Discretionary Review Abbreviated Analysis HEARING DATE: MARCH 5, 2015

Date: February 26, 2015
Case No.: **2014-000977DRP**
Project Address: **360 EUREKA STREET**
Permit Application: 2014.03.07.0226
Zoning: RH-2 [Residential House, Two-Family]
40-X Height and Bulk District
Block/Lot: 2749/013
Project Sponsor: Andy Rodgers
Rodgers Architecture
156 South Park
San Francisco, CA 94107
Staff Contact: Marcelle Boudreaux – (415) 575-9140
Marcelle.Boudreaux@sfgov.org
Recommendation: **Do not take DR and approve as proposed**

Abbreviated Discretionary Review
Case Number 2014-000977DRP
360 Eureka Street

RESPONSE TO DISCRETIONARY REVIEW

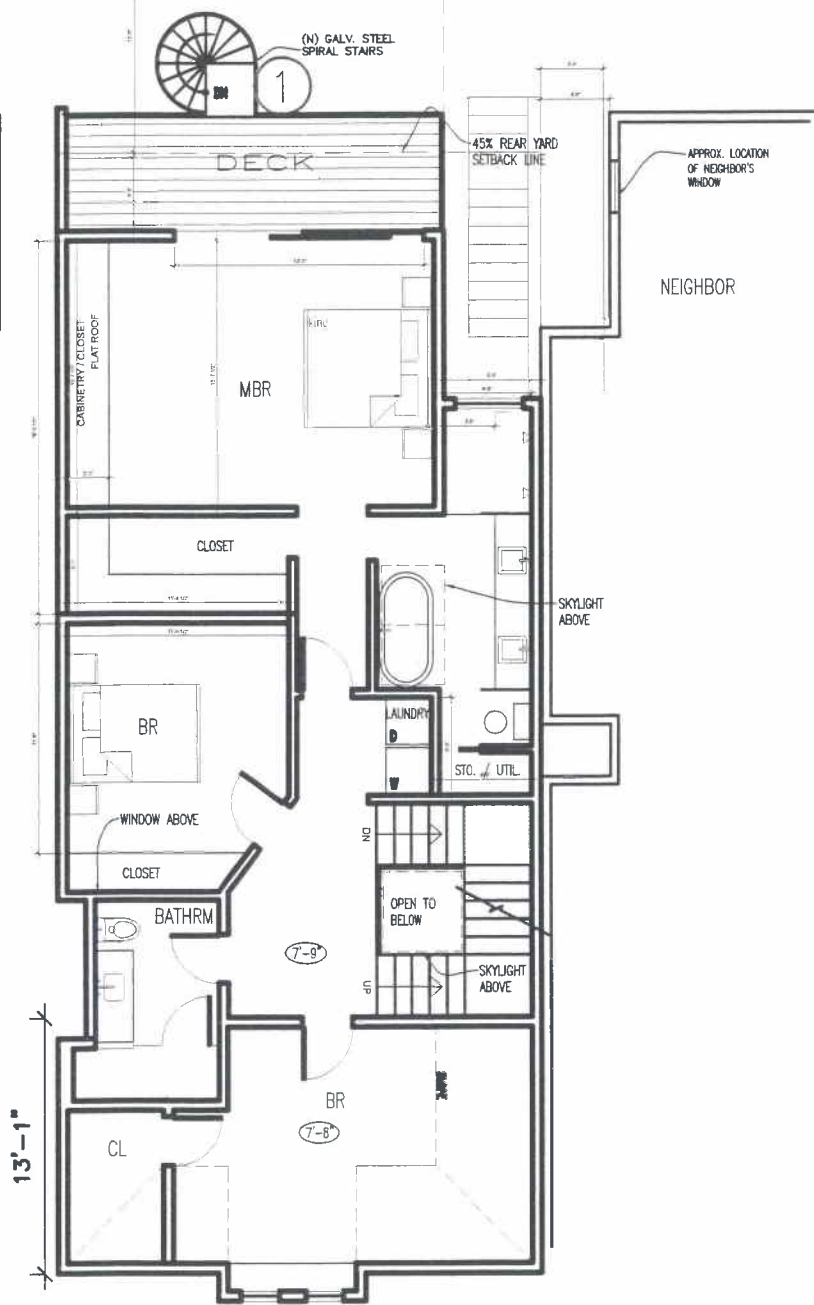
Spiral staircase move closer - email Nov 6

Spiral staircase removed

1st Floor Deck set back on 366 sidewalk (3 feet) North and South (see plans) Nov 20th, Open guardrail

We asked Andy Rodgers, Rodgers Architecture
to submit our concerns -
According to Marcelle Boudreau there were no
complaints - Got information at the Planning Dept.
I had called Louh Jessing to find out if they
were involved - then Mr. Boudreau had taken over

View from 366 Eureka

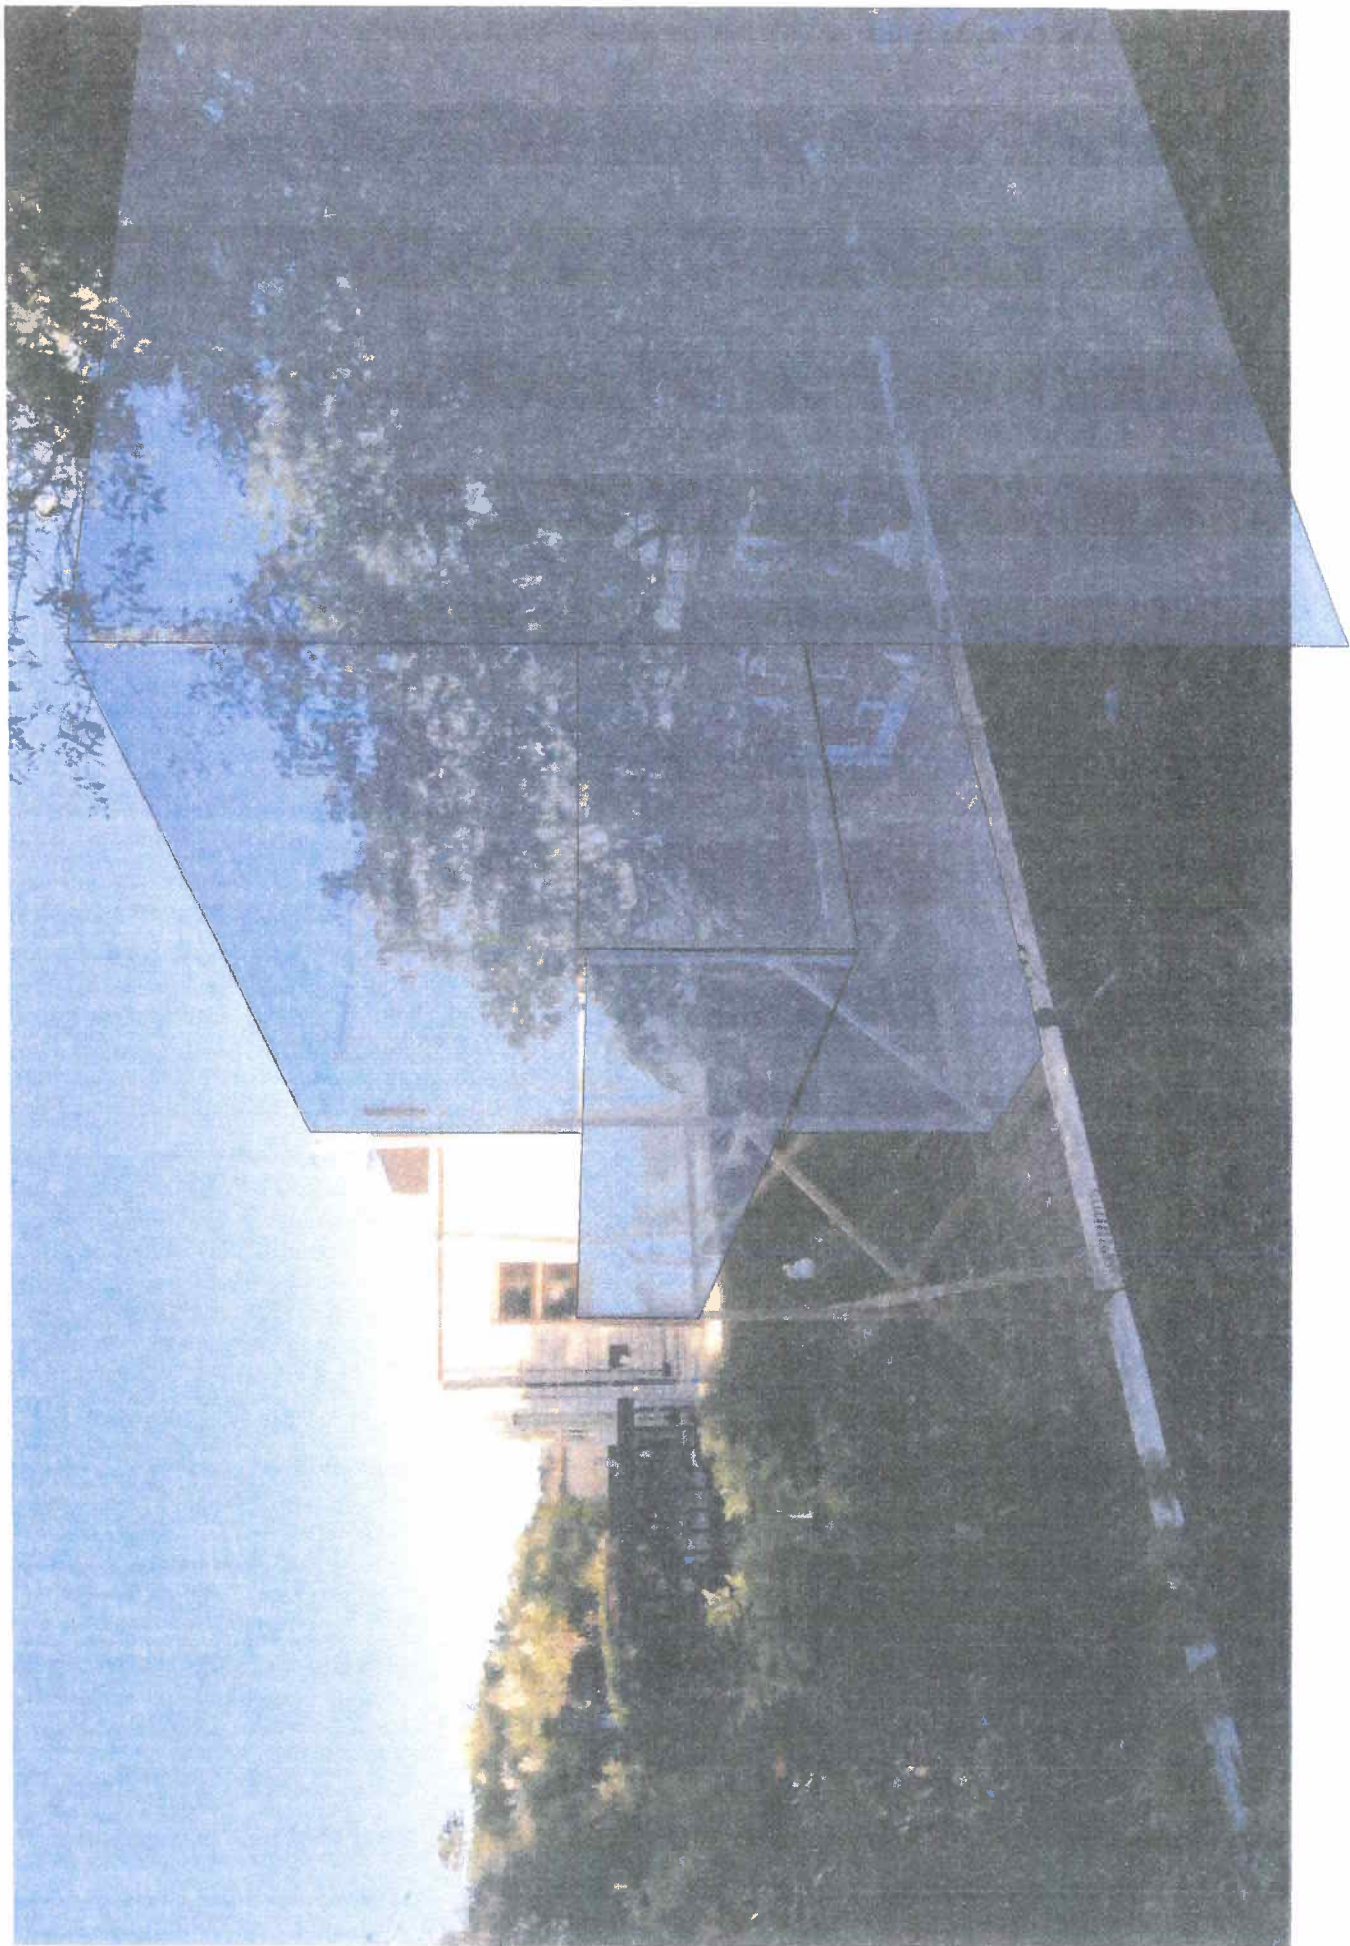
④ OPEN GUARDRAIL
@ NORTH + SOUTH
SIDE OF ROOF
DECK

EXISTING &
PROPOSED
SITE PLANS

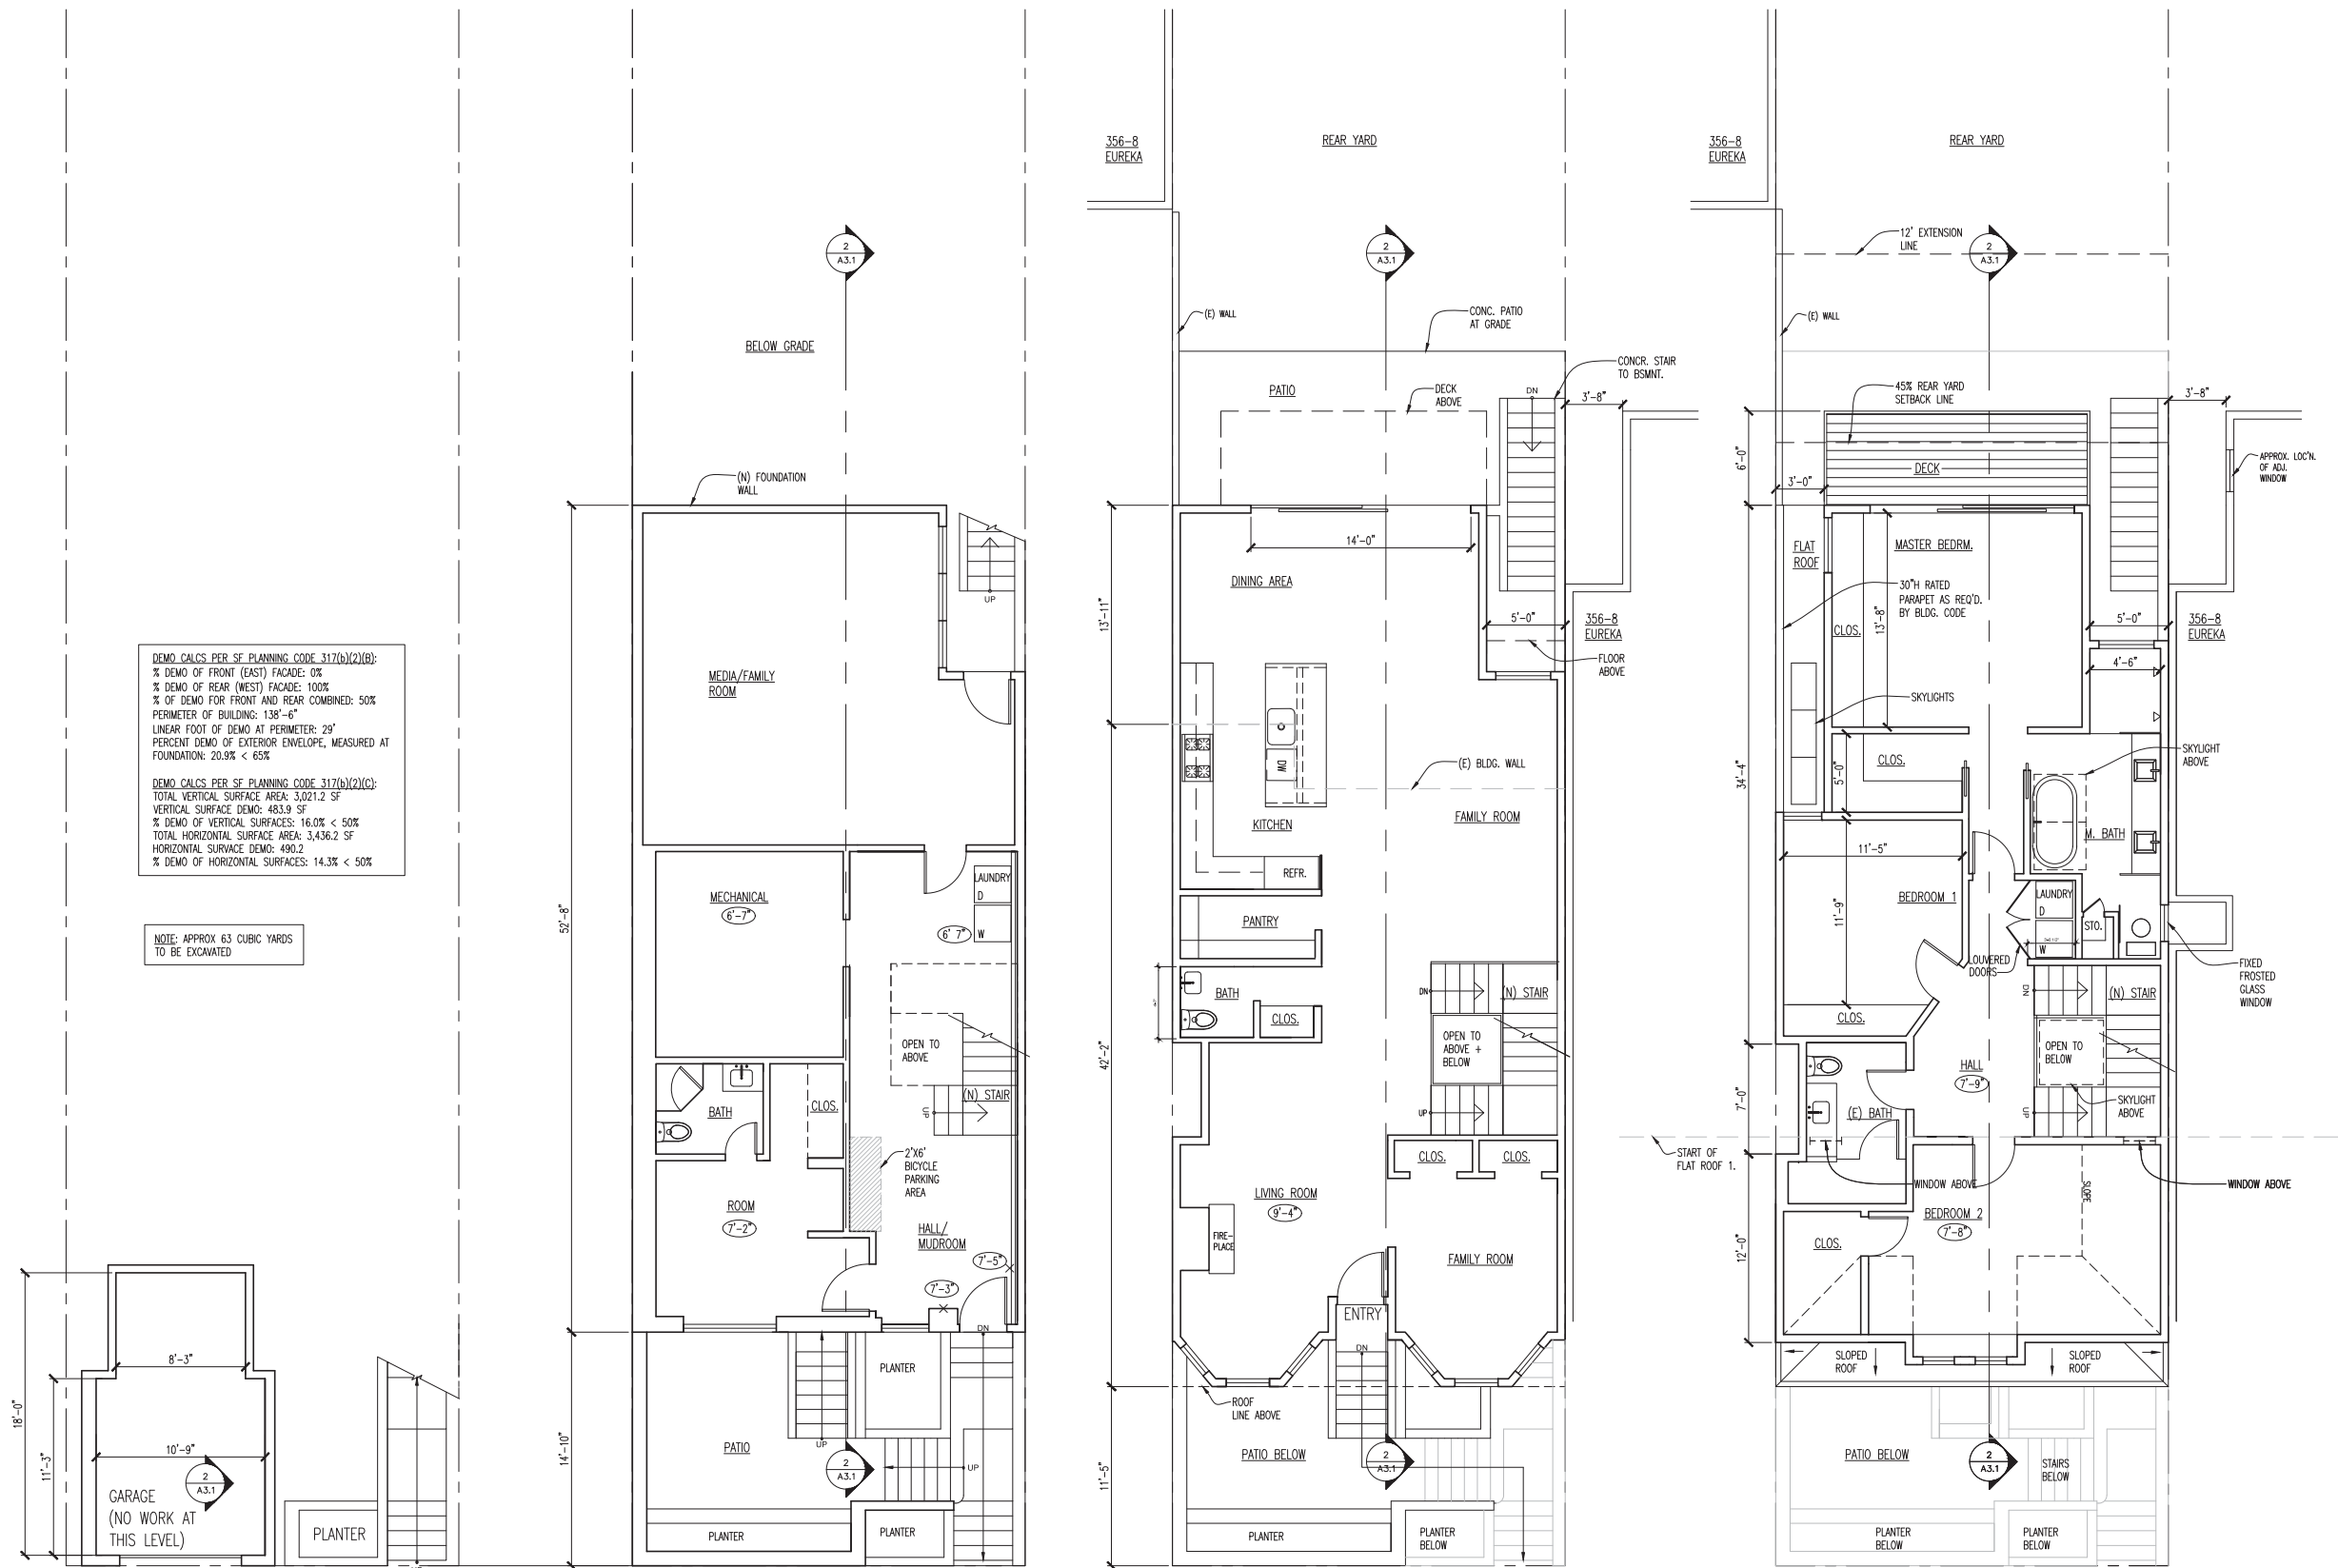
The original proposed horizontal addition, submitted to DBI on March 7, 2014, was already shy of the allowable rear yard setback, and of significance was set back by 5' on the north side so as to mirror the setback of the building at 356-8 Eureka Street, as recommended by the planning department's Residential Design Guidelines. The proposed set back is larger than that of Ms. Gottlieb's; the intent is to preserve as much access to southern sunlight as possible to the 358 Eureka kitchen window. Please see attached floor plans, Exhibit A.
